Rooftop Ventilation Ducts

Medical Centre, 14-18 Newton Road London, W2 5LT 29th April 2024

EXISTING PLAN & ELEVATION

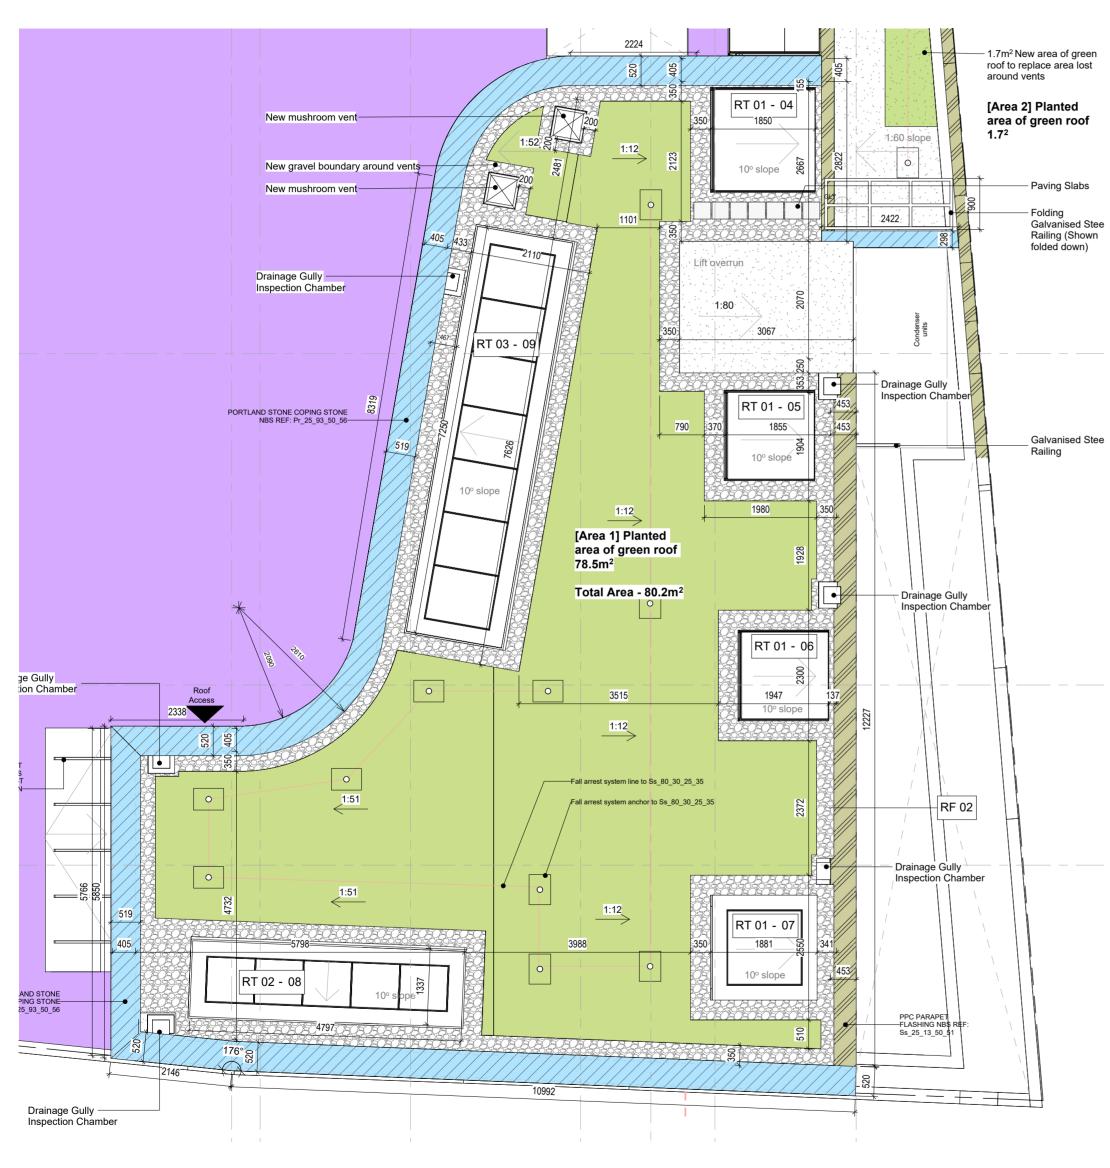
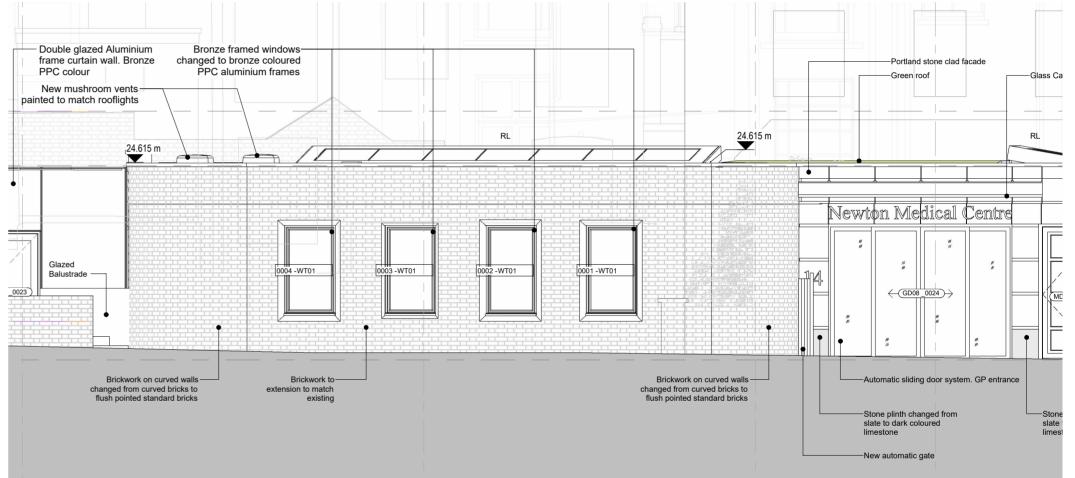
The existing ducts are made from galvanised steel and are approximately 750mm above parapet level.

One duct is required to exhaust stale air and the other is required to draw in fresh air.

PROPOSED PLAN & ELEVATION

The proposed mushroom vents will be approx 150mm higher than the parapet.

This is significantly lower than the existing ducts and the visibility from the ground will be extremely limited.

In order to reduce the visual impact further, the proposed mushroom vents will be painted in a similar bronze colour to the surrounds to the existing roof lights.

The area of the mushroom vents will be larger than the existing ventilation ducts. The mushroom vents also require an area around them to be cleared of planting.
